Rezoning Transportation Analysis

Petition Number: 2022-160

Revision Log:

Date	Description
02-23-23	First Review (PDM)
03-23-23	Second Review (PDM)
04-25-23	Third Review (PDM)

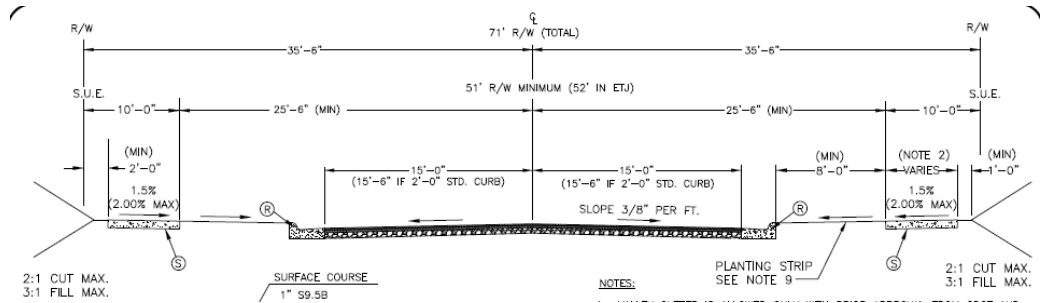
- a. ~~Mount Holly Road:~~ Location of curb and gutter to be installed at 33 feet from roadway centerline to accommodate the Charlotte Streets Map roadway typical section of a four plus lane avenue with shared use path.
~~UPDATED COMMENT 3.23.2023:~~ Future back of curb needs to be show at 33ft for entire Mount Holly Road frontage for planning purposes.

- ~~Creston Road:~~ Location of curb and gutter to be installed at 17.5 feet from roadway centerline in accordance with the Local Residential Wide typical section (CLDSM U-03).

Label and dimension the curb and gutter from the centerline for each road on the site plan.
